HEARINGS OFFICER DECISION AND FINAL ORDER

Community Service, Design Review, Significant Environmental Concern for Water Resources, Major and Minor Variance

Case File: T3-2013-2861

Summary: Applicant is proposing to operate the Lao Buddhist Center Northwest from the subject property and convert existing buildings and construct various improvements to accommodate the use of the site.

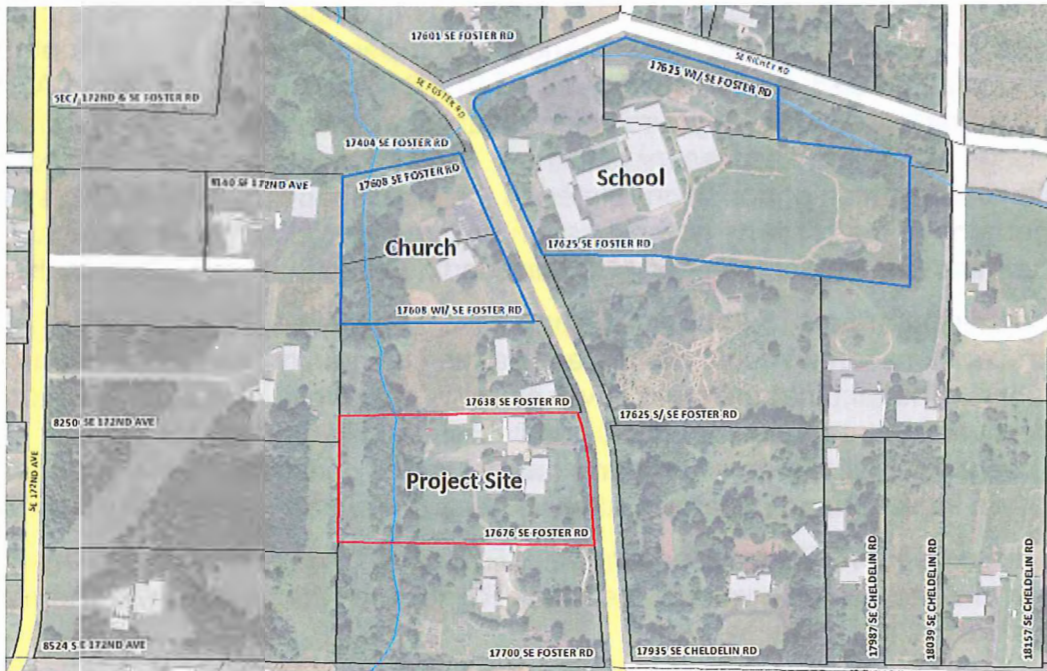
Since the non-permitted structure will be used as an "accessory uses to the above" [MCC 11.15.7020A.27.], it must also meet the required 20-foot side yard requirement of MCC 11.15.7025A.2. For the Major Variance, the applicant must demonstrate compliance with the practical difficulty standard above and criteria 1, 2, 3 and 4 in order for the Major Variance to be granted. Since the structure was never authorized by Land Use Planning, its existence in its present location is not a practical difficulty for the property owner as it is not lawful. There is no property right for an unlawful building or use. The subject property has area available to construct the patio cover in compliance with the required 20-foot side yard. In addition, its present unauthorized location is within 65 feet of the wetland boundary and will require a "No Alternative" findings under MCC 11.15.6429B. Staff believes making this finding does not seem feasible as the patio cover could be moved to the southern portion of the site where it would be further than 100 feet from the wetland boundary. [See Section 9.00 for additional findings]. *There is no practical difficulty in lawfully establishing the proposed*

patio cover on the site and meeting the required 20-foot side yard requirements.

Hearings Officer: The revised site plan, Exhibit H.1, proposes moving the Patio Cover to a new location west of the Monk Residence which eliminates the need for a Major Variance.

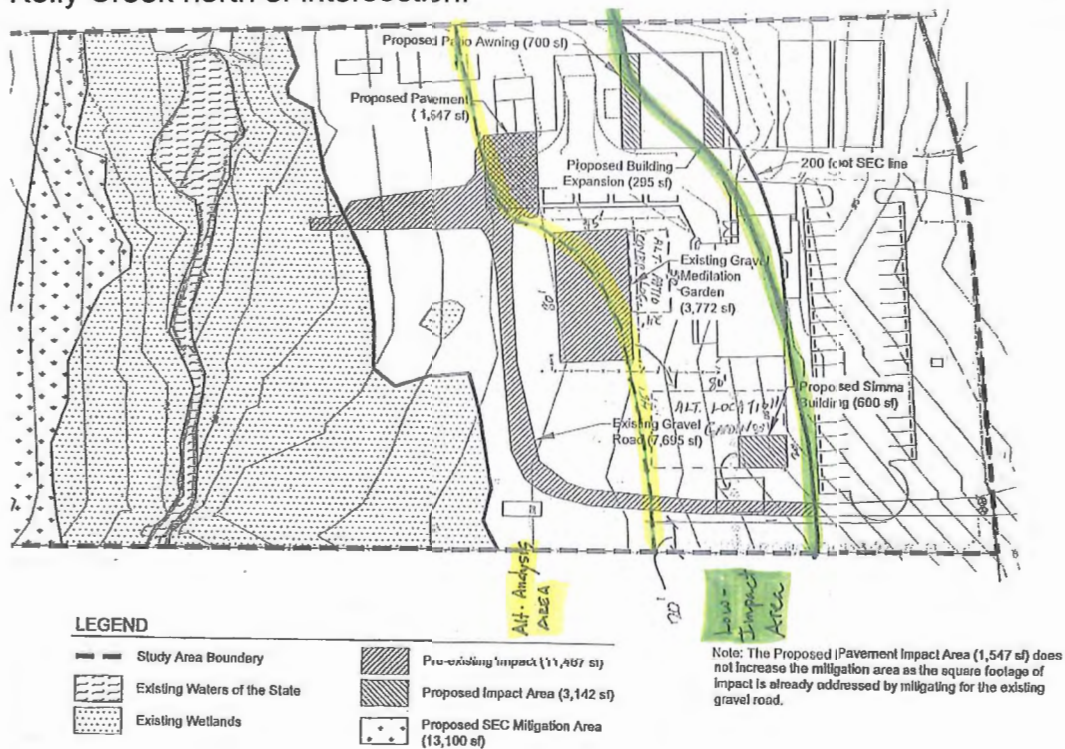
Staff: The 20-foot side yard requirement of MCC11.15.7025A.2. applies to all properties within the unincorporated Multnomah County area for any properties seeking to convert structures or build a new building for a community service use. At present, a Baptist church exists two properties to the north and an elementary school is located to the northeast on the corner of Foster Road and Richey Road. These two uses are both community service uses and the standards would also apply to any new buildings being constructed on their site or additions. The 20-foot side yard requirement is not a circumstance or condition that applies only to this property in the area.

The subject parcel is crossed by a protected SEC-wr stream with related wetlands. This protected riparian area runs north-south across the western portion of the site. The stream travels northward from the Clackamas County properties through the subject site and continues northward to the Foster & Richey Intersection and joins Kelly Creek north of intersection.

As represented in the above aerial photograph, other parcels in the area have the same site conditions as the subject parcel.
